REGULATORY INFORMATION DISTRIBUTION SYSTEM (RIDS)  
DISTRIBUTION FOR INCOMING MATERIAL 50-305

RESPONSE TO NRC REQUEST OF 07/11/78... FORWARDING ADDL INFO RE SUBJECT  
FACILITY'S SPENT FUEL POOL MODIFICATION ... W/ATT.

PLANT NAME: KEWAUNEE

Docket 50-305  
Operating License DPR-43  
Spent Fuel Pool Modification

EFFECTIVE MASS OF A FUEL ASSEMBLY  
CONTAINED WITHIN A STORAGE CAN

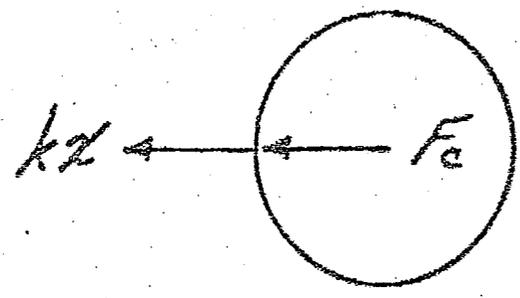
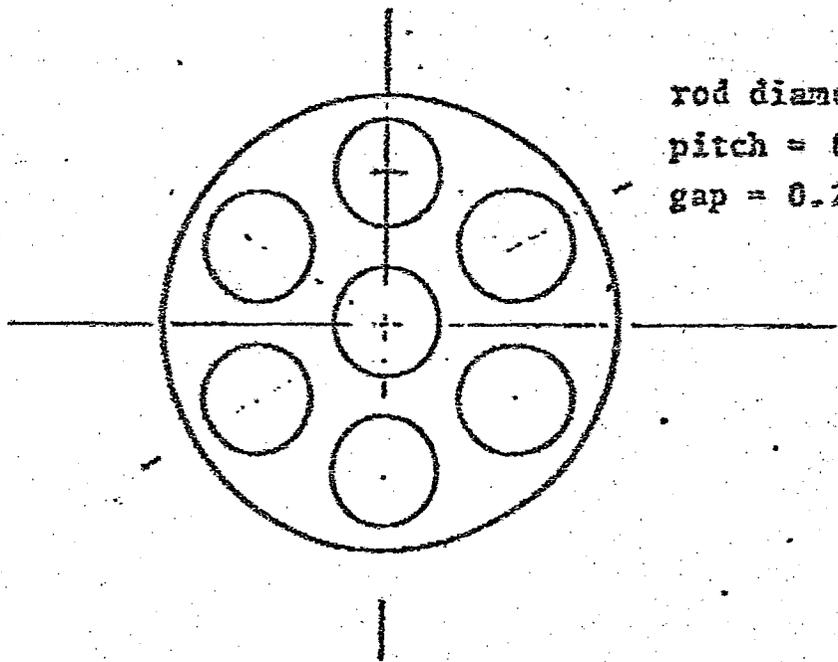
- (a) In accordance with Regulatory Guide 1.92, the three orthogonal spatial components of the earthquake shall be considered simultaneously. The responses to earthquakes applied in all three directions,  $X_1$ ,  $X_2$ , and  $X_3$ , should be combined by the SRSS method. Additionally, the requirements concerning combining responses of closely spaced modes should be considered.
- (b) All modes with frequencies up to 33 Hz in each of the three directions should be included in the analyses.
- (c) Discuss the boundary conditions assumed in the model when the  $X_2$  and  $X_3$  earthquakes are imposed on the racks and base.

The effective mass of a system consisting of a can containing water plus fuel as shown in the sketch below will be calculated. The approach taken follows the paper by Fritz (see Ref. 1) in which the fluid is taken to be frictionless and incompressible. Based upon potential theory, fluid forces are developed for two-body motions with fluid coupling.

For a cylinder immersed in an infinite fluid,  $M_H = M_1$ , i.e.,  $\beta = 1$ . For an array of cylinders contained within a cylinder, i.e., a fuel assembly within a fuel storage can,  $\beta > 1$ . For arrays of circular cylinders, a computer program, AMASS (Ref. 3) is available to calculate  $\beta$ . The model shown on the next page

was used to calculate  $\beta$  for a typical geometry. Due to computer limitations, the fuel was modeled as an array of seven rods surrounded by a circular cylinder. Fuel rod diameter and pitch and fuel assembly to can gap were maintained. A value of 1.9 was calculated for  $\beta$ . Use  $\beta = 2$  as a typical value. Then  $M_H = 2 M_1$ .

Sketch 12-1

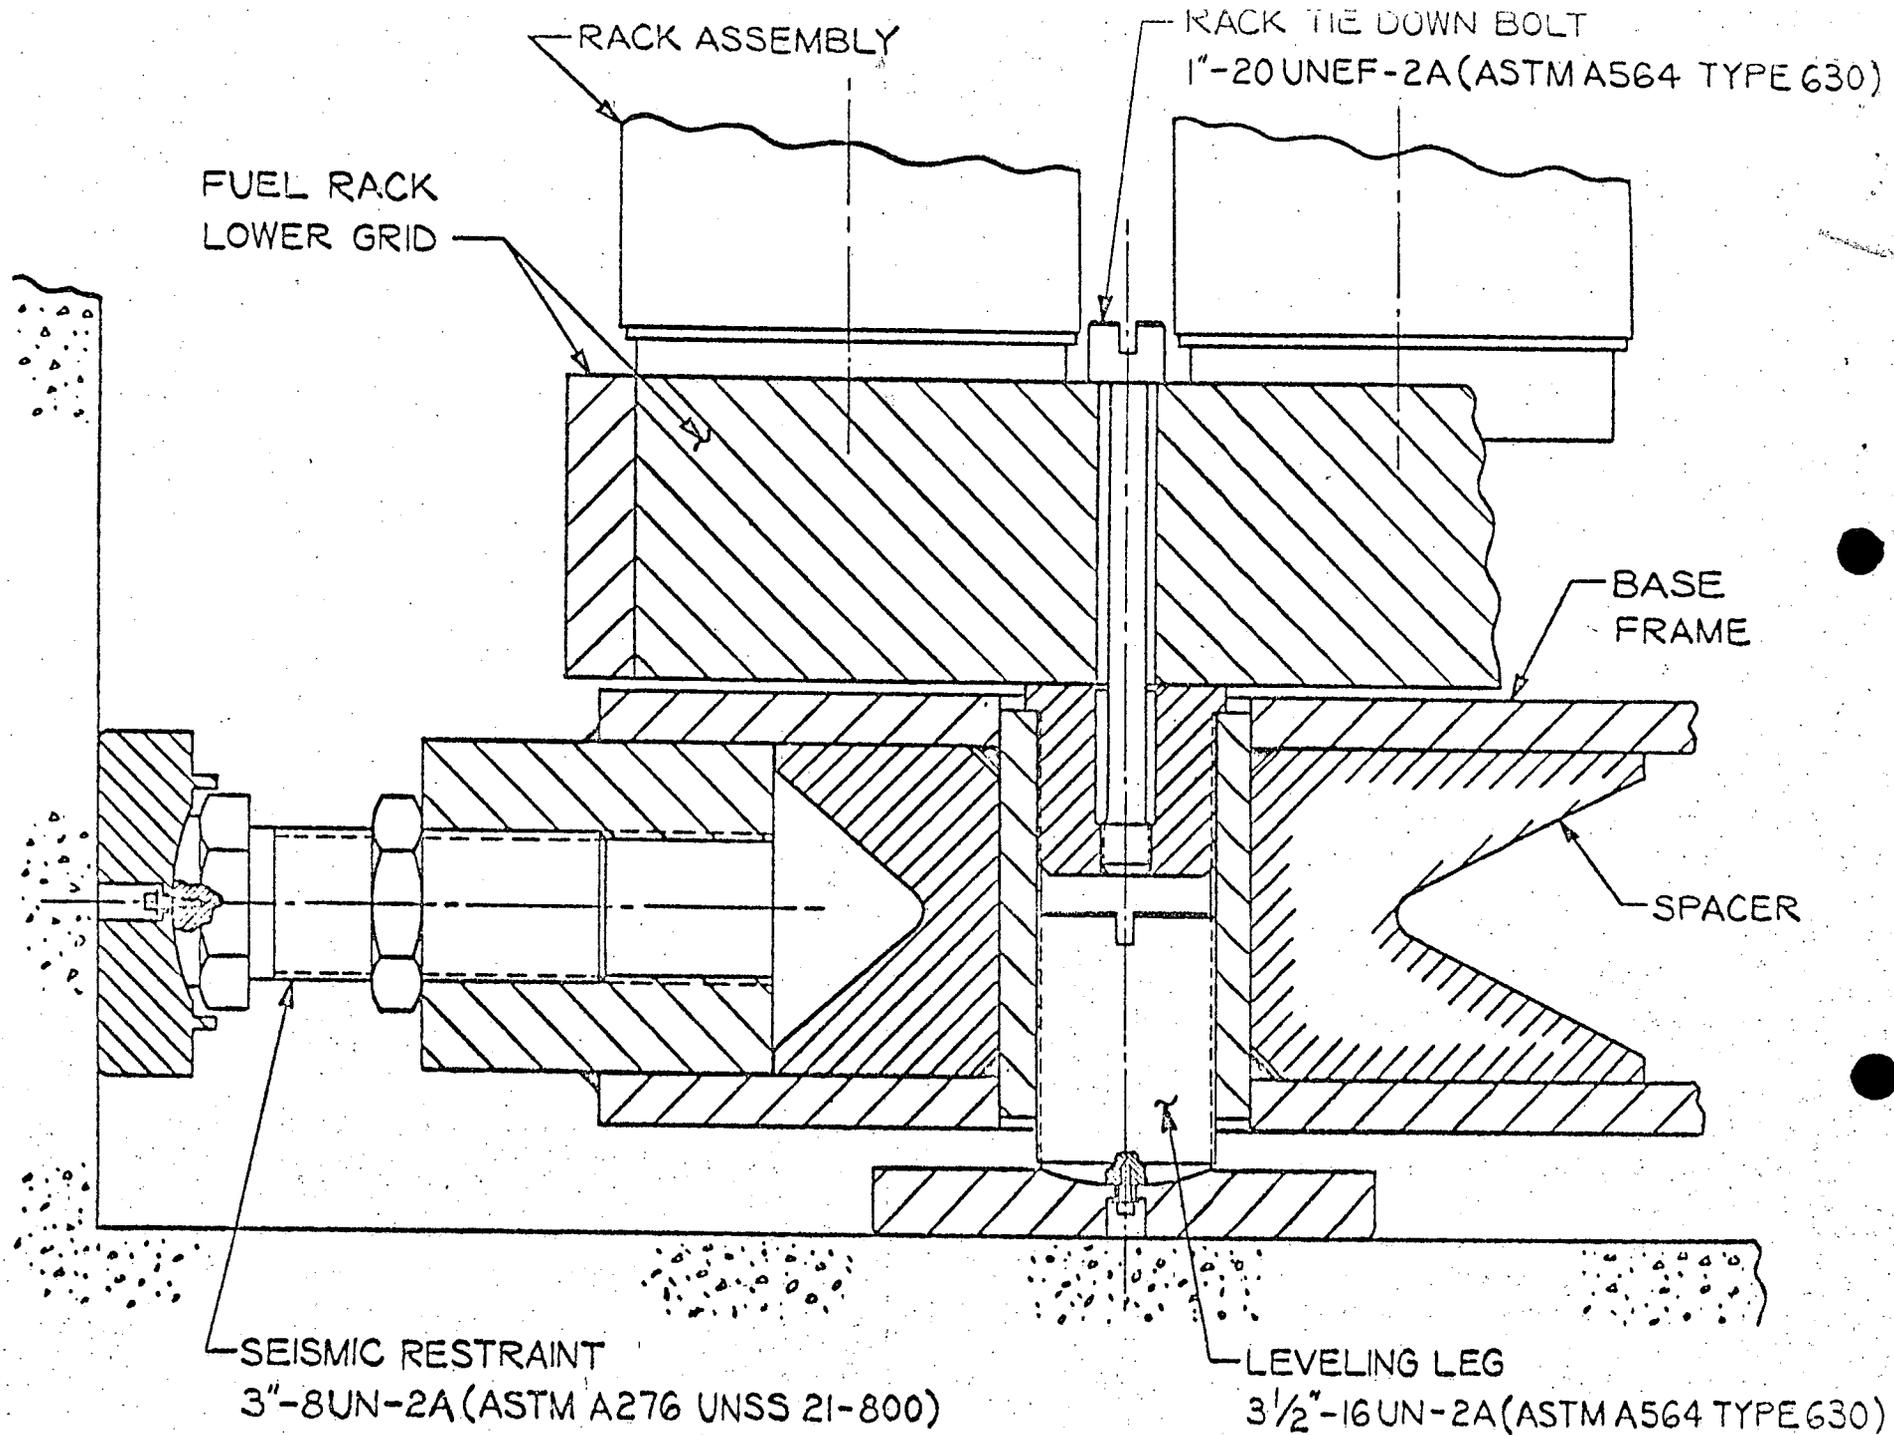
Provide details of the interface in the East-West direction between base frames and pool walls. Also, provide details of the interface between the top portions of all rack assemblies. Provide details of the interfaces around the equipment laydown area. Enough details should be provided so that a correlation between the assumed boundary conditions in the seismic analyses and the actual conditions can be made.

The attached sketches provide the information requested noting that the individual cans are formed into 9 x 10 racks by welding to upper and lower grid structures and the racks are in turn bolted to the base frames which are bolted together to entirely fill the pool and are restrained from moving by "compression only" seismic restraints to the pool walls.

1. INTERFACE BETWEEN BASE FRAMES AND BASE FRAMES & WALLS IN THE EAST/WEST DIRECTION ARE AS SHOWN ON EXISTING SKETCHES 12-1 AND 12-2
2. INTERFACE BETWEEN TOP OF RACKS AT LOCATIONS MARKED "X" ARE AS SHOWN ON ATTACHED SKETCH 12-3
3. INTERFACE BETWEEN RACKS AND FRAME AROUND EQUIPMENT LAYDOWN AREA ARE TYPICAL TO A RACK TO RACK INTERFACE
